Work Order ID 114063

Item Name: Seat Pan

D3022-1 SEAT PAN

Linda/Mel – As discussed, please proceed with manufacturing of qty(3) D3022-1 Seat Pans. Manufacture from 0.040" 2024T3 sheet in lieu of 0.032" and communicate the W/O's B/N to Customer Support for the no charge PO. ChrisP or Alex to sign off on the W/O. Jackson and I will be delivering the parts directly to Capitale Helicopteres; please have them packaged and ready in DART truck by end of day tomorrow.

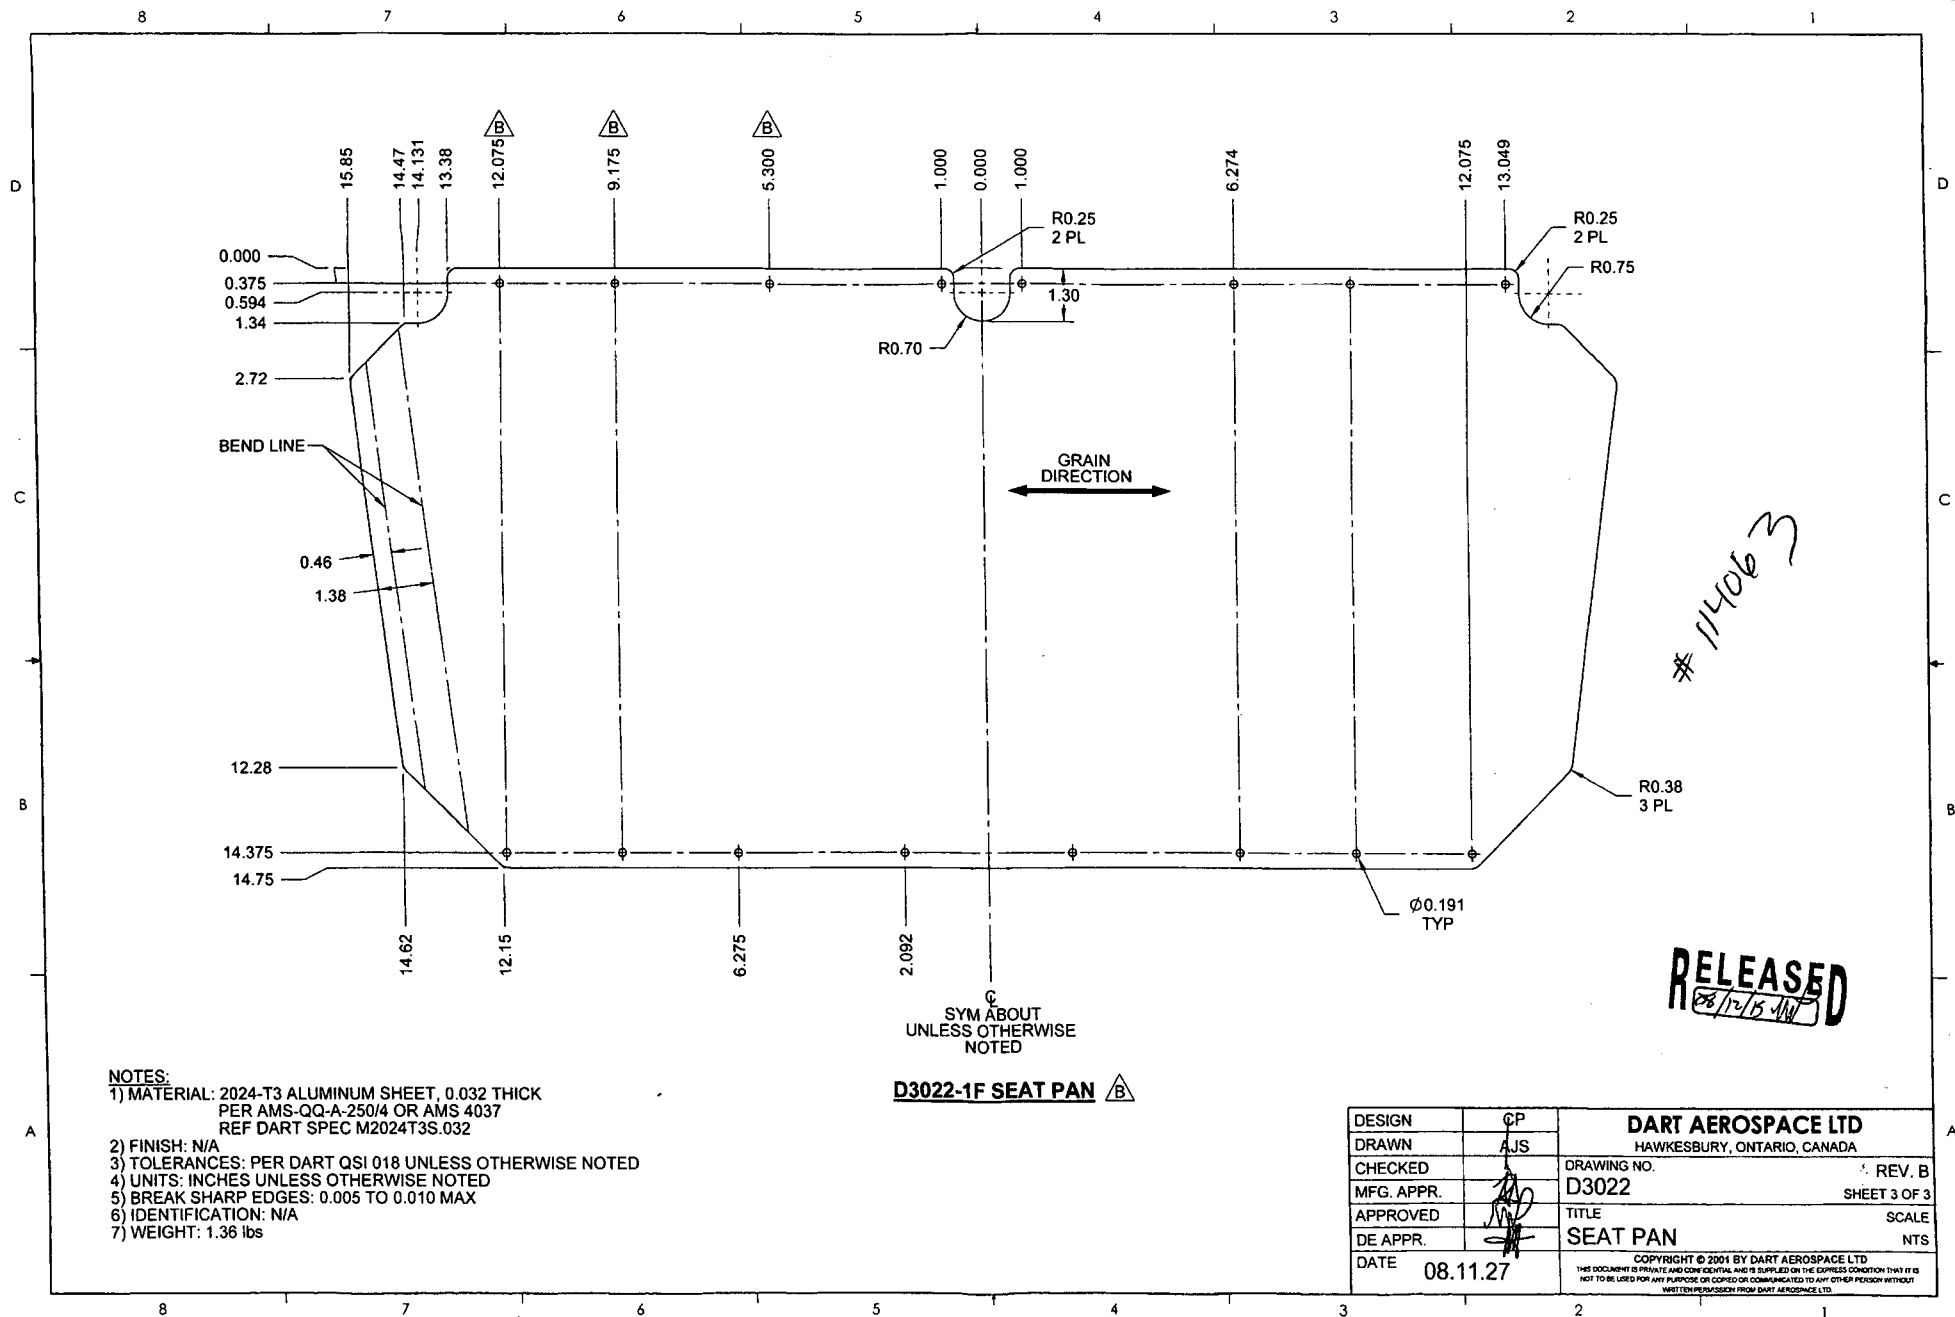
Root Cause	Date	Step	Qty	Description of work order update or non-conformance	Initial Chief Eng	Action Description	Sign & Date	Verification	QC Inspector
Design									
Doc/Data	14/3/4	100	3	CUSTOMER'S PAN IS CRACKING IN SERVICE	DAS 12 9-89	INCREASE THICKNESS TO 0.040" FOR THIS CUSTOMER ONLY.	DAS 12 9-89	DAS 27 9-89	27 9-89
Equip/Tooling					14/3/4	Acceptable deviation, makes part stronger.	14/3/4	14/3/4	14/3/4
Handling/Pre									
Material									
Operator									
Offset/Setup									
Process									
Supplier									
Training									
Transport									
Unapproved

Weird. Probably makes sense to increase to 0.040" thick as a deviation for these 3 seats and see how it goes. Need to make sure the holes are properly deburred.

Our D3022-1 drawing specifies 0.032". Would it make sense to go one gauge number thicker (0.040")? Or should we simply replace their seat pans with blank D3022-1 to 0.032" thickness?
